STATE OF CONNECTICUT  
CONNECTICUT SITING COUNCIL

IN RE: :  
 :  
 APPLICATION OF CELLCO PARTNERSHIP : DOCKET NO. 471  
 D/B/A VERIZON WIRELESS FOR A :  
 CERTIFICATE OF ENVIRONMENTAL :  
 COMPATIBILITY AND PUBLIC NEED FOR :  
 THE CONSTRUCTION, MAINTENANCE :  
 AND OPERATION OF A WIRELESS :  
 TELECOMMUNICATIONS FACILITY AT :  
 208 KIRK ROAD (a/k/a 1075 PARADISE :  
 AVENUE) IN HAMDEN, CONNECTICUT : MAY 23, 2017

**RESPONSES OF CELLCO PARTNERSHIP D/B/A VERIZON WIRELESS  
TO CONNECTICUT SITING COUNCIL PRE-HEARING QUESTIONS – SET 2**

SHEET NUMBER:  
**C-2A**

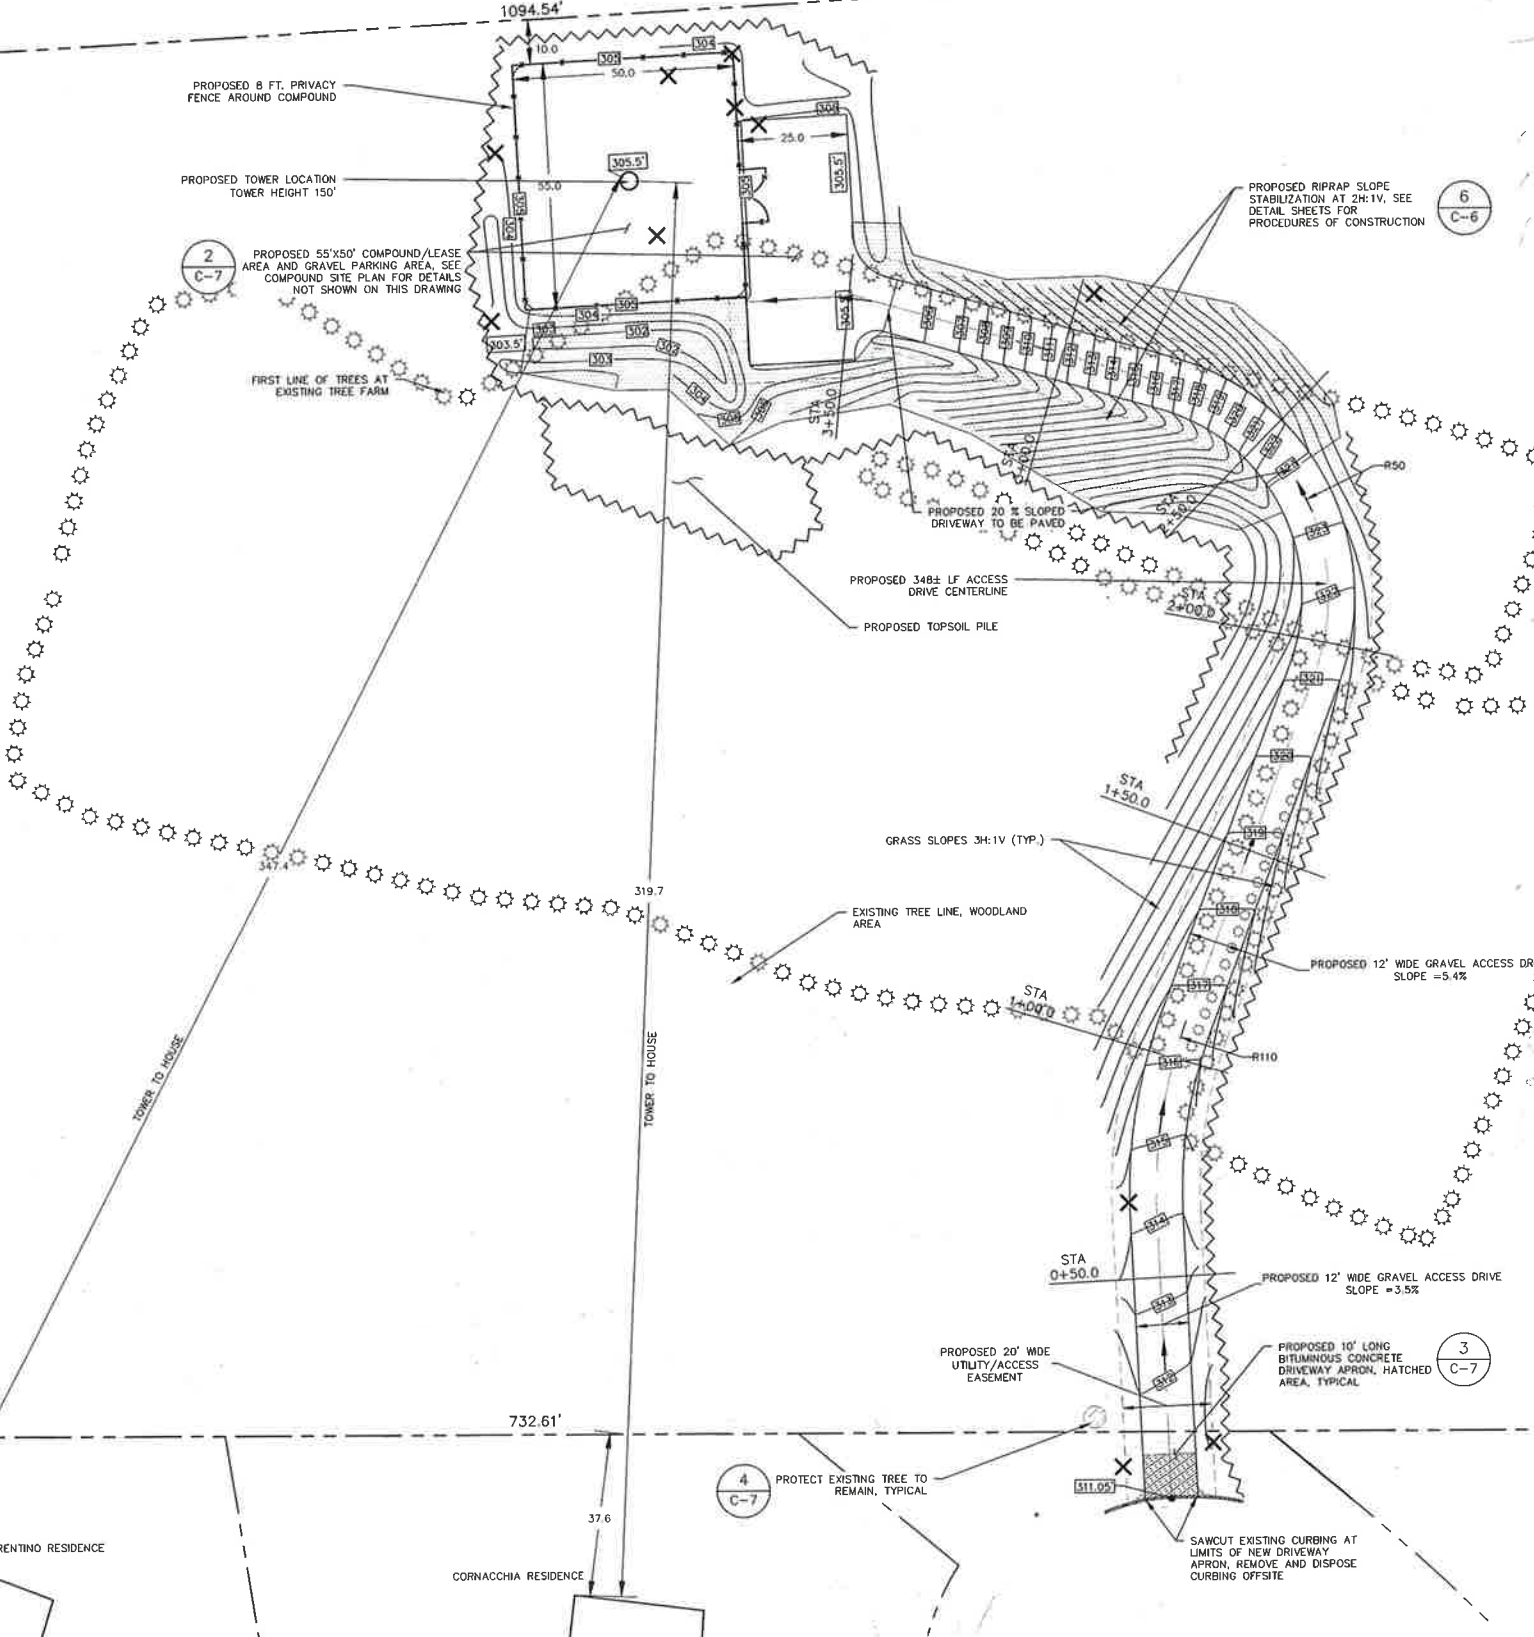
As discussed at the May 2, 2017 hearing (Tr. 1, pp. 74-76), is it possible to relocate the tower site to either the ridge immediately east of the site or to the ridge north-northeast of lessor's house? If yes, please provide site detail. If not, why not?

Alternate Site 1: This alternative is located approximately 157 feet east northeast of the proposed tower site at a ground elevation of approximately 305.5 feet above mean sea level (AMSL). This location extends off the north side of the current tree farm plating area into a relatively level and wooded area. Using this alternate location would provide additional separating distances between the cell site and the neighbors to the south, while maintaining all intervening vegetation, including trees bordering the cul-de-sac where the access road would originate. Trees requiring removal to develop this location are on the north side of the subject parcel and do not provide screening to neighboring (developed) properties to the south. The neighboring property to the north is undeveloped and wooded. Although slightly higher (approximately 10') in ground elevation as compared to the proposed site, this location provides for natural topographic screening to the south and Country Club Road. To achieve a similar antenna height as the proposed Hamden 8 Facility, the height of a monopole at the Alternate Site 1 location would need to be 150 feet above ground level (AGL), ten (10) feet lower than the tower at the proposed site. A Partial Site Plan drawing for Alternate Site 1 is included in Attachment 4.

Preliminary storm water controls for each of the alternative access driveway locations and tower sites provided on the site plans included in Attachments 1, 4 and 5.

Temporary stockpile locations are shown on the site plans included in Attachments 1, 4 and 5.
